# ENCORE APARTMENTS

DPD # 3020094  
2ND DESIGN RECOMMENDATION  
20 DECEMBER 2016

**PROJECT ADDRESS:**  
3010 1st Ave.

Guardrail 1

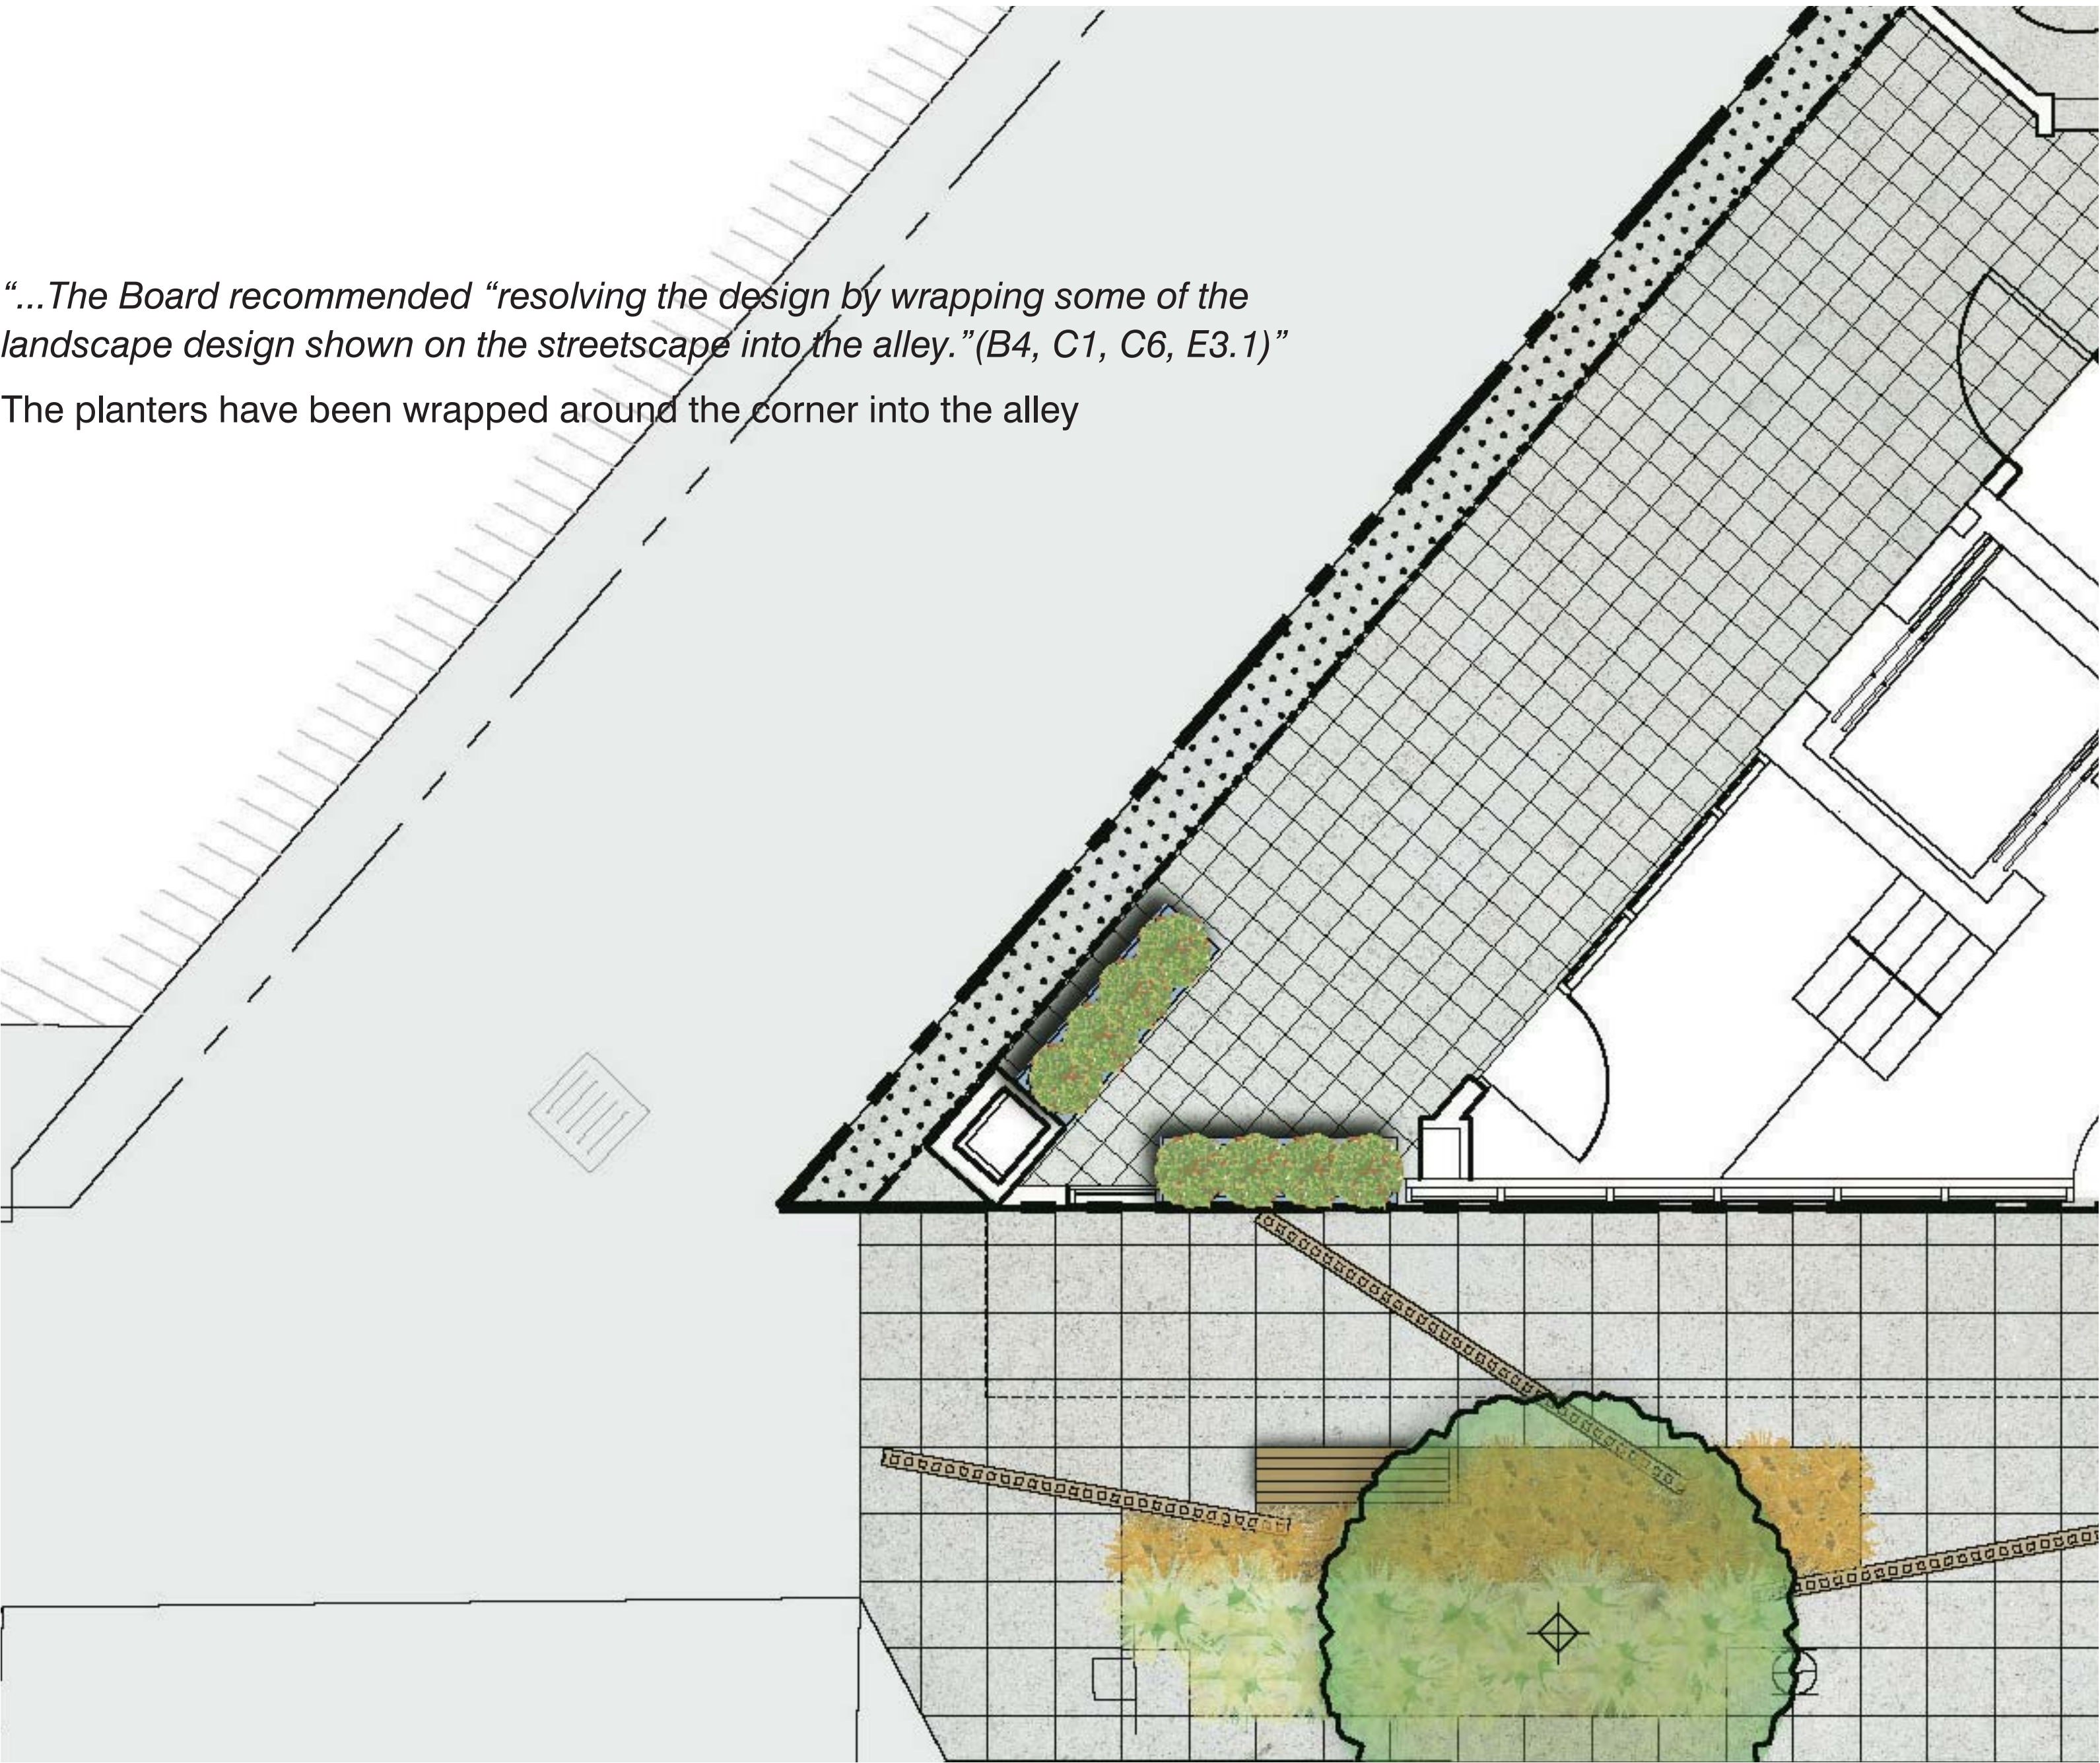
*“...The Board was concerned with the lack of balconies shown in the preferred massing option and recommended the applicant study using articulated rather the juliet balconies to break up the building facade...a taut skin facade expression, In order to create a smooth plane, the board recommended accentuating the verticals or minimizing the joints entirely (B4.2, B4.3)”*

Decks are often not provided at units this small because of construction cost and it’s effect on rents. The design of this guardrail allows the tenant to open the sliding glass door to ventilate the unit and get an outside experience. It is minimalist in design. It’s proximity to the facade creates a more “taut skin” expression.

Landscaping at Alley

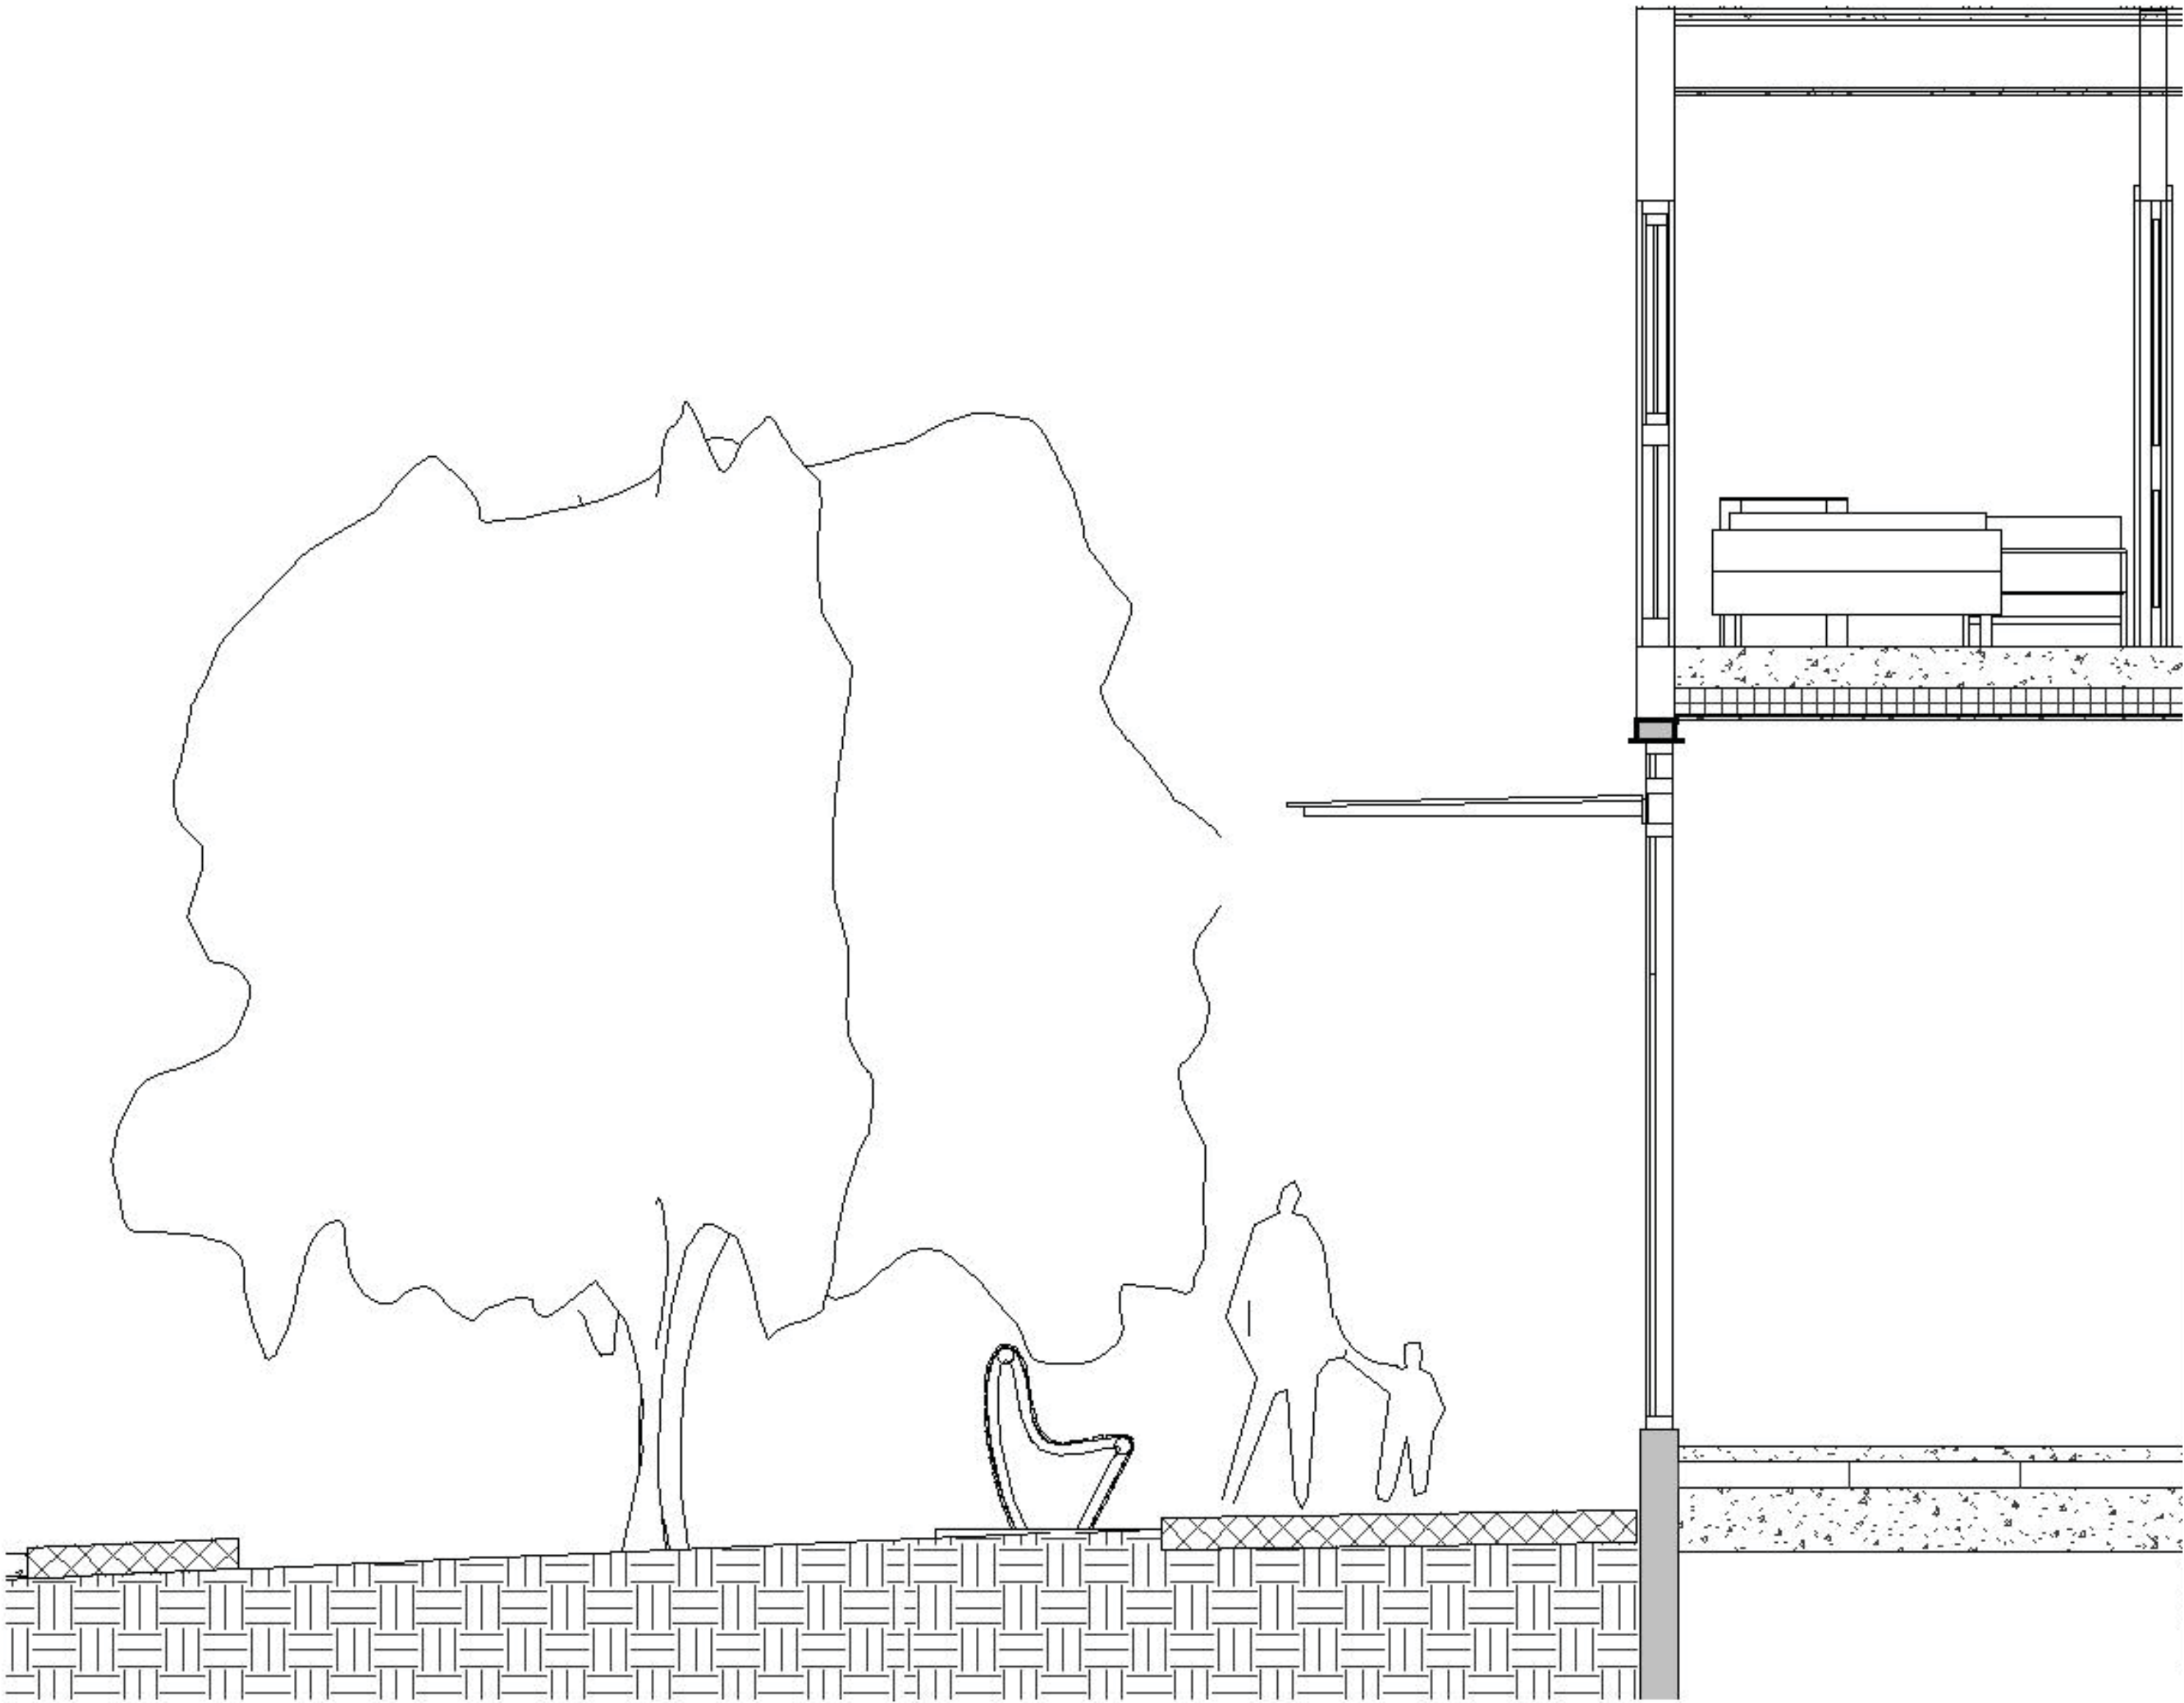
*“...The Board recommended “resolving the design by wrapping some of the landscape design shown on the streetscape into the alley.”(B4, C1, C6, E3.1)”*

The planters have been wrapped around the corner into the alley
